## Cycle / Gearshifting

**Status report about the work of the task force on  
cycle and gearshift issues**

**Heinz Steven**

**14.04.2017**

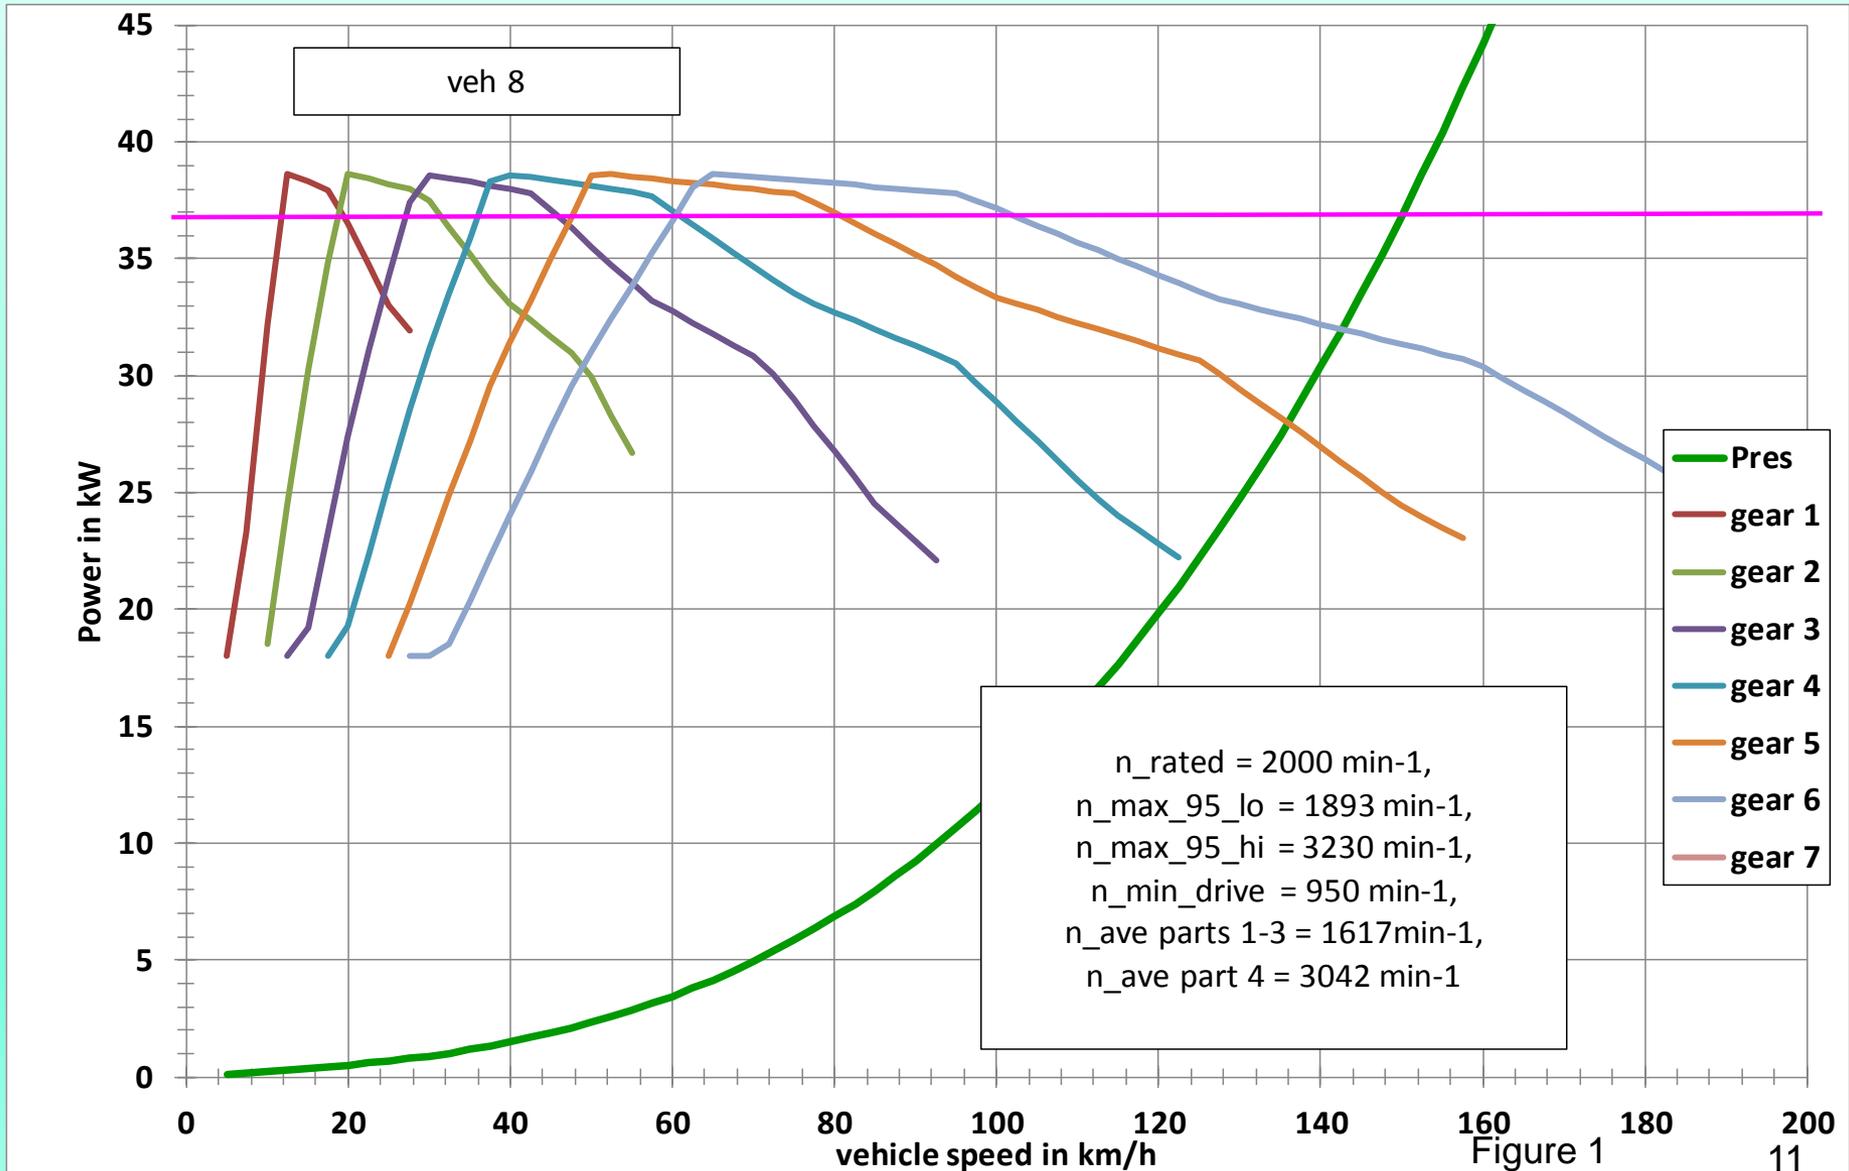
- The Japanese colleagues provided 3 example vehicles for the round robin test of gearshift calculation tools.
- One of these examples could not correctly be calculated with the ACCESS tool (version 31.01.2017) because the design of the full load power curve led to a too low value for  $n_{\max\_95}$  ( $n_{95\_low}$ ).
- As a consequence the 2 second rule for acceleration phases (keep a given gear for at least 2 seconds) would lead to higher engine speeds than  $n_{95\_low}$ .
- The vehicle has an extreme wot power curve with  $n_{\text{rated}}$  of 2000  $\text{min}^{-1}$ , but a usable speed range up to 5000  $\text{min}^{-1}$ . The vehicle speed at rated engine speed is 63,6 km/h, the engine speed at max. vehicle speed is 4480  $\text{min}^{-1}$ .

- The available power for different gears and the required power for constant speed driving are shown in figure 1.
- $n_{95\_low}$  is  $1893 \text{ min}^{-1}$  (indicated by the pink line parallel to the x-axis); this leads to the fact that the 2. gear can only be used for just 1 second at  $t = 538 \text{ s}$  and at  $t = 1030 \text{ s}$ .
- A similar example is vehicle 78 (a N2 example provided by Japan), whose power curves are shown in figure 2. The 2. gear can only be used for just 1 second at  $t = 141 \text{ s}$ ,  $t = 515 \text{ s}$  and  $t = 1030 \text{ s}$ .

Figure 2

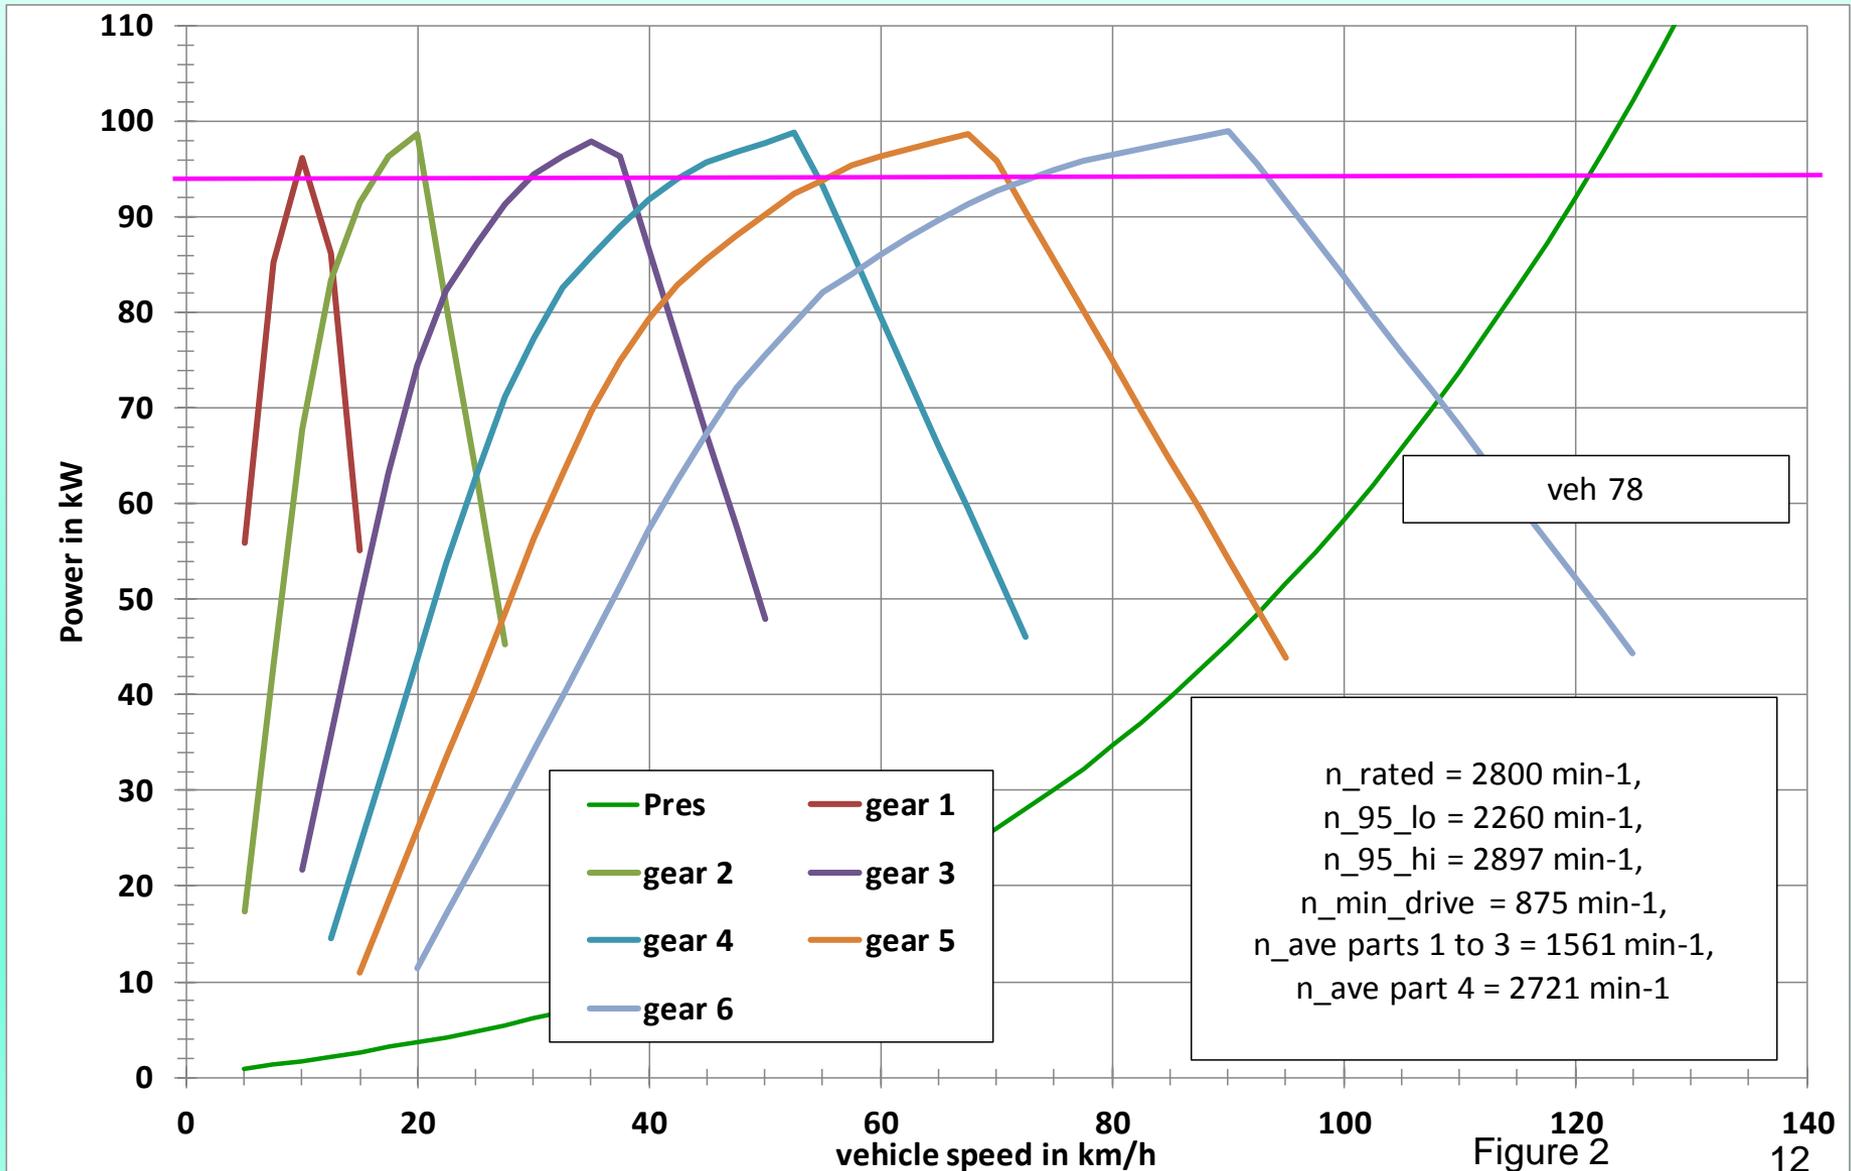
- Both cases have an extreme high ratio between the engine speed  $n_{\max}(ng_{v_{\max}})$  at maximum cycle speed in  $ng_{v_{\max}}$  (the gear in which the maximum vehicle speed is reached) and  $n_{\max_{95}}$ .
- This ratio is 2,18 for vehicle 108 and 1,80 for vehicle 78. Typical ratios for “normal” vehicles are between 0,65 and 1,25.
- From checks for a series of vehicles can be concluded, that a ratio of 1,7 would be an appropriate borderline.
- Conclusion: A further requirement needs to be added to paragraph 2 (g) or the current requirements need to be replaced in order to solve this problem.

- The addition of a further requirement is not satisfying, because this is then the 3<sup>rd</sup> time that  $n_{\max\_95\_low}$  needs to be amended in order to eliminate contradictions with the 2 second rule.
- But one could also replace  $n_{\max\_95}$  by a weighted average of  $n_{95\_low}$  and  $n_{\max}(ng_{vmax})$  for such cases, in order to meet the 2 second rule.
- The following examples make clear that it would be more appropriate to replace the current requirements by a better definition of  $n_{\max\_95}$ .
- Another option would be to skip  $n_{\max}$  requirements completely.

Figure 3

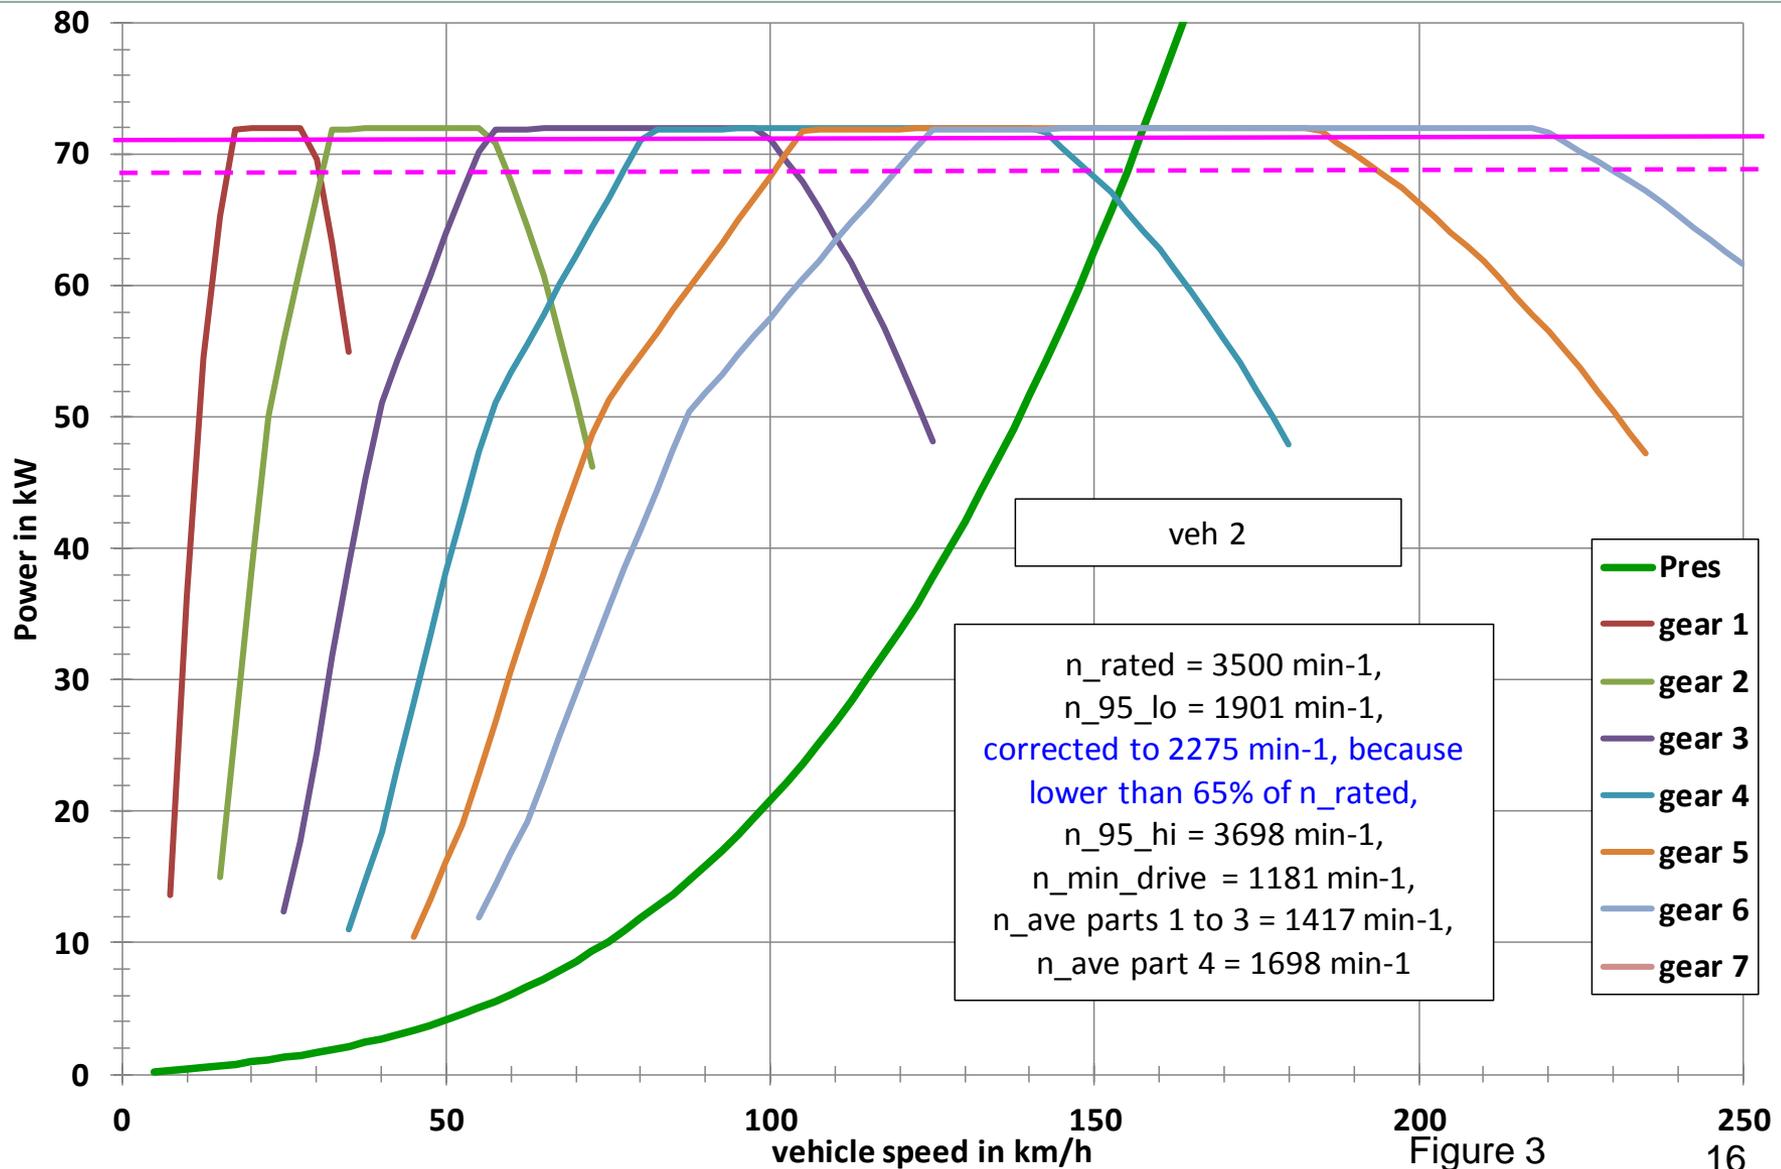
- **Figures 3 and 4 show the available power for all gears and the required power for constant speed driving for two other example vehicles with the same transmission design and almost the same wot power curve.**
- **The rated engine speed for vehicle 2 is at the upper end of the maximum power plateau (3500 min<sup>-1</sup>) while the rated engine speed for vehicle 3 is at the lower end (2000 min<sup>-1</sup>).**

- It is obvious that there will be no difference between both vehicles with respect to the driving behaviour in practical use. But the key values for the gearshift calculation are significantly different.
- $n_{95\_low}$  is  $1900 \text{ min}^{-1}$  in both cases. But 65% of rated engine speed is  $2275 \text{ min}^{-1}$  for vehicle 2 and  $1300 \text{ min}^{-1}$  for vehicle 3.  $n_{\max\_95}$  needs to be corrected according to para 2 (g) to 65% of rated engine speed ( $2275 \text{ min}^{-1}$ ) for vehicle 2 and to  $1,1 * n_{\min\_drive} * (n/v)_2 / (n/v)_3$  ( $1909 \text{ min}^{-1}$ ) for vehicle 3.
- A common solution for both vehicles can be found, if the ratio between  $n_{95\_high}$  and  $n_{95\_low}$  would be used as criterion for an increase of  $n_{\max\_95}$  instead of the existing requirements.

- A better solution would be to replace rated engine speed by  $n_{\max\_95\_high}$  in the equation for the calculation of  $n_{\min\_drive}$   
$$(n_{\min\_drive} = n_{idle} + 0,125*(n_{\cancel{rated}}n_{95\_high} - n_{idle}))$$
- Of course, the weighting factor of 0,125 would then have to be changed, but both vehicles would get exactly the same  $n_{\min\_drive}$ . This proposal of the chairman was also not yet discussed in the GSTF.
- Another finding from the gearshift calculations for vehicles 2 and 3 was, that the skipping of gears during decelerations required two consecutive seconds with gear 0 because of the low  $n_{\max\_95}$  values.

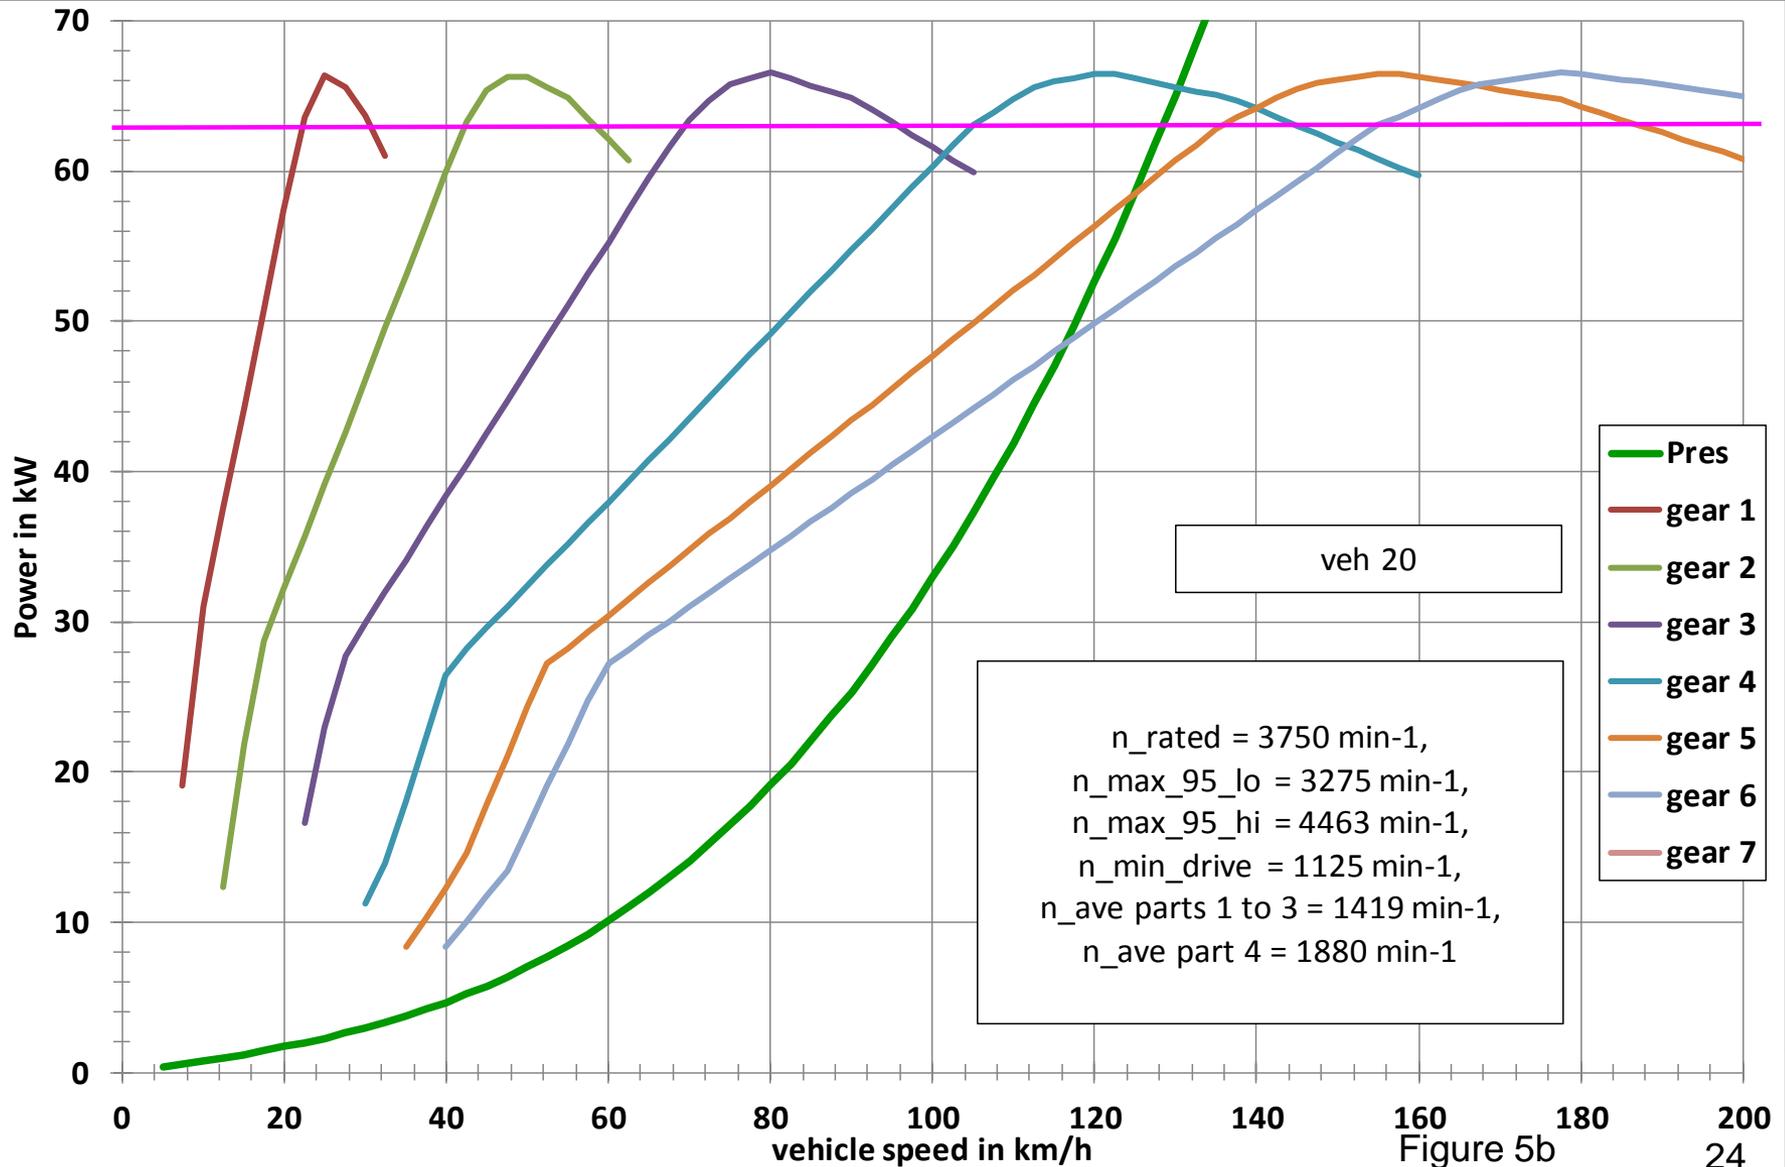
- One of the example vehicles for the RRT have a transmission design, so that the maximum vehicle speed is reached in gear  $ng-2$  (see figure 5).
- This is not covered by the current specifications in paragraph 2 (i).
- In order to cover also gear  $ng-2$ , the text needs to be amended as shown later.

- The example vehicle shown in figure 5 has a transmission design which is the opposite of those shown in figures 1 and 2. The two highest gears of this 7speed transmission are designed as “overdrives”, so that the maximum vehicle speed is reached in 5<sup>th</sup> gear.
- In this case an upshift to a higher gear could occur at the transition from an acceleration or constant speed phase to a deceleration phase, which is not in line with practical use (see annexed Excel file) but not prohibited by the current prescriptions in annex 2.
- This is also the case for 4 of the example vehicles for the RRT.

(i)  $ng_{v_{max}}$ ,  $v_{max}$

$ng_{v_{max}}$ , the gear in which the maximum vehicle speed is reached and shall be determined as follows:

If  $v_{max}(ng) \geq v_{max}(ng-1)$  and  $v_{max}(ng-1) \geq v_{max}(ng-2)$ , then,

$ng_{v_{max}} = ng$  and  $v_{max} = v_{max}(ng)$ ,

if  $v_{max}(ng) < v_{max}(ng-1)$  and  $v_{max}(ng-1) \geq v_{max}(ng-2)$ , then

$ng_{v_{max}} = ng-1$  and  $v_{max} = v_{max}(ng-1)$ ,

otherwise,  $ng_{v_{max}} = ng-2$  and  $v_{max} = v_{max}(ng-2)$
